Access Compliance Report

Public Rights-of-Way

(Curb Ramps)

Intersection ID: N/A	Main Street: GLENBURN_LN	Cross Street: LOCHY_LN	Location: NW
ADA ID: B273FA5657B8	Ramp Type: PerpDiag	Initial Pass/Fail: Fail	Overall Compliance: No
Severity Score: 21.25			
Codes/Mitigation Info/Possible Solution		Field Measurements/Component Compliance

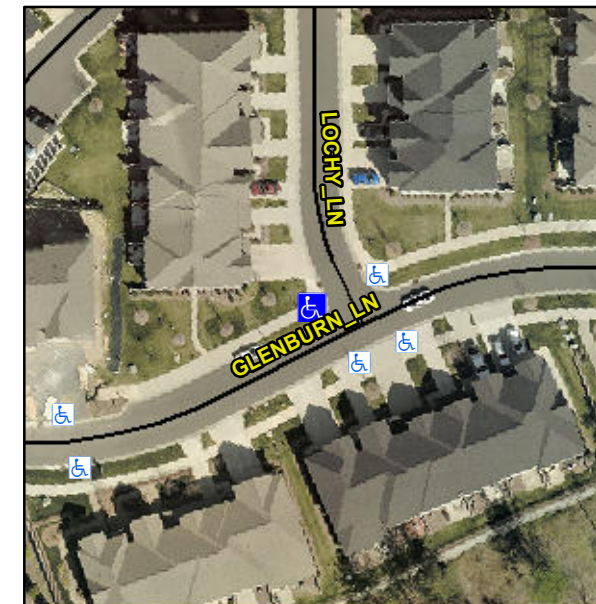
Not Found, R304.5.1, R304.2.2

Compliance	Description	Data	Compliance	Description	Data
N/A	Ramp Length (in)	76.0	No	Ramp Slope (%)	8.5
No	Ramp Width (in)	46.5	Yes	Ramp XSlope (%)	0.5
N/A	Flare Type LT	N/A	N/A	Flare Type RT	N/A
N/A	Flare Slope LT (%)	N/A	N/A	Flare Slope RT (%)	N/A
N/A	Flare Traversable LT?	N/A	N/A	Flare Traversable RT?	N/A
N/A	Landing Length (in)	N/A	N/A	DWS Provided?	N/A
N/A	Landing Width (in)	N/A	N/A	DWS Contrast?	N/A
N/A	Landing Slope (%)	N/A	N/A	DWS Length (in)	N/A
N/A	Landing X Slope (%)	N/A	N/A	DWS Full Width?	N/A
N/A	Landing Curb? (Y/N)	N/A	N/A	DWS Offset (in)	N/A
N/A	Shared Landing?	N/A			
N/A	Gutter Ponding?	N/A	N/A	Gutter Slope (%)	N/A
N/A	Gutter Lip Ht (in)	N/A	N/A	Gutter X Slope (%)	N/A
N/A	Painted X Walk1?	No	N/A	Painted X Walk2?	No
	X Walk 1 Direction	To SE		X Walk 2 Direction	To NE
N/A	X Walk 1 Width (in)	N/A	N/A	X Walk 2 Width (in)	N/A
	X Walk 1 Slope (%)	2.1		X Walk 2 Slope (%)	3.1
	X Walk 1 X Slope (%)	2.6		X Walk 2 X Slope (%)	0.1

Remove & Replace Curb Ramp With Two New Directional Ramps or Equivalent.
